Product Change Notification / JAON-17NPXF486

CCB 3280.003 Final Notice: Qualification of MTAI as new final test site for selected AT24C0xx, AT24C16x, AT24C32E, AT24C64B, AT24HC0xx, AT93C46x, and AT93C86A device families available in 8L PDIP package.

CCB 3280.003
Pre and Post Change Summary
PCN# JAON-17NPXF486

Pre and Post Change Summary - Pin 1 Orientation

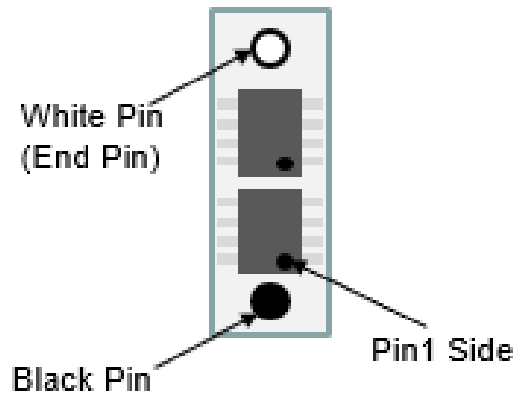
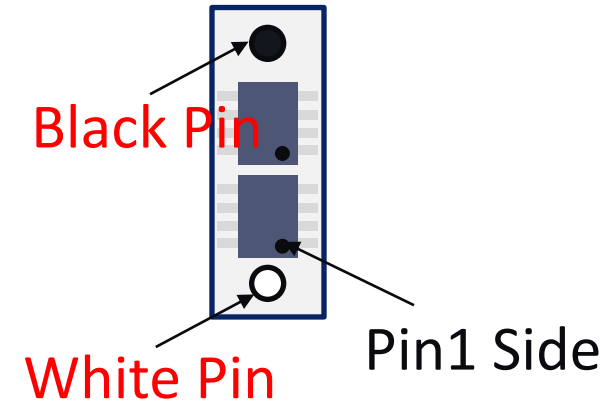
Pre Change	Post Change
Final Test Location	Amkor Technology Philippine (P1/P2), INC. (ANAP)	Microchip Technology Thailand (HQ) (MTAI)
Packing Media	Tube	Tube
Base Quantity Multiple (BQM)	50	50
Units per Tube	50 units	50 units
Tubes per Bag	50 tubes	40 tubes
Total units per Bag	2,500 units	2,000 units

Pre and Post Change Summary – Tube Drawing

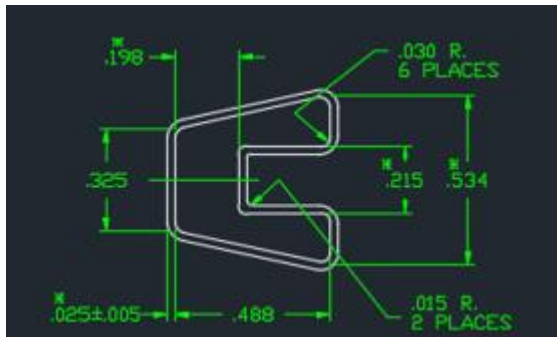
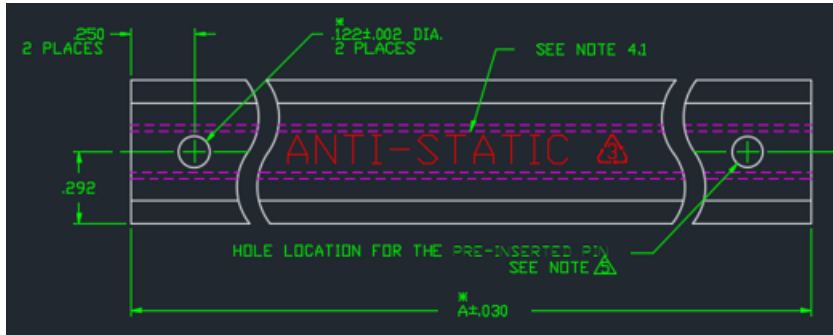
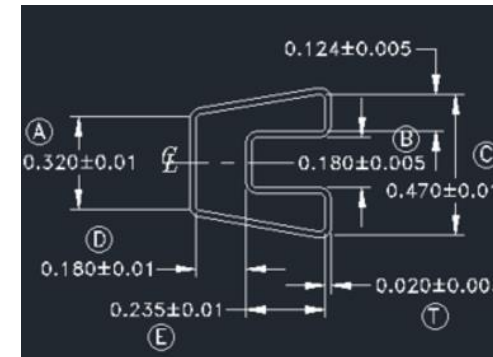
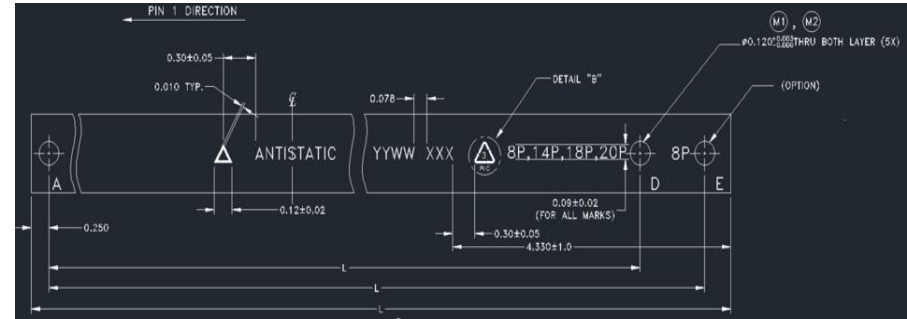
Plant	Tube Length (inch)	Center Hole A to Center Hole D (inch)	A (inch)	B (inch)	C (inch)	D (inch)	E (inch)	T (inch)	Color
ANAP	20.00 +/-0.030	19.50 +/- 0.030	0.325 +/- 0.010	0.215 +/-0.010	0.534 +/- 0.010	0.198 +/- 0.010	0.290 +/- 0.010	0.025 +/- 0.005	Transparent Clear
MTAI	20.33 +/-0.025	19.28 +/- 0.050	0.320 +/-0.010	0.180 +/-0.005	0.470 +/-0.010	0.180 +/-0.010	0.235 +/-0.010	0.020 +/-0.003	Transparent Clear

Pre and Post Change Summary – Packing Method

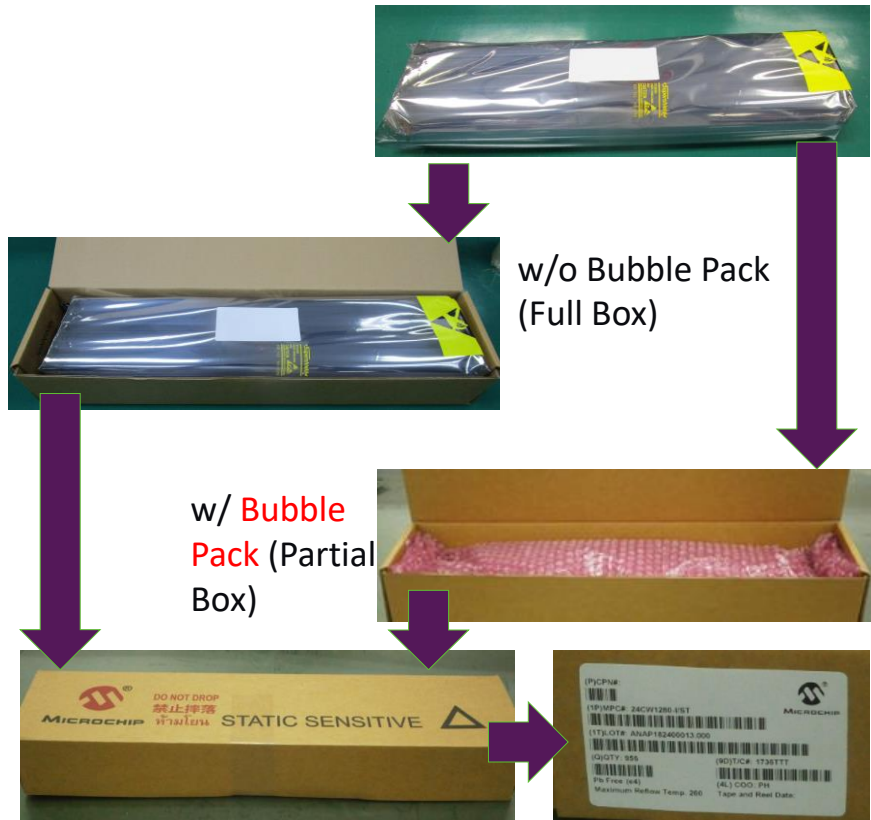
Bag type	Dimension
Antistatic Pink Gusset	140 x 760mm

Carton	Dimension W x L x H (cm)	Number of Bag/carton
M01-020 (PD)	15x71.5x5	1
M01-021 (PI)	17x65x8	1
M01-022 (PP)	15.5x62x14	2
M01-023 (PT)	22.5x63x16.5	3
M01-024 (P4)	32x63x15.5	4
M01-034 (P5)	36x63x16.5	5
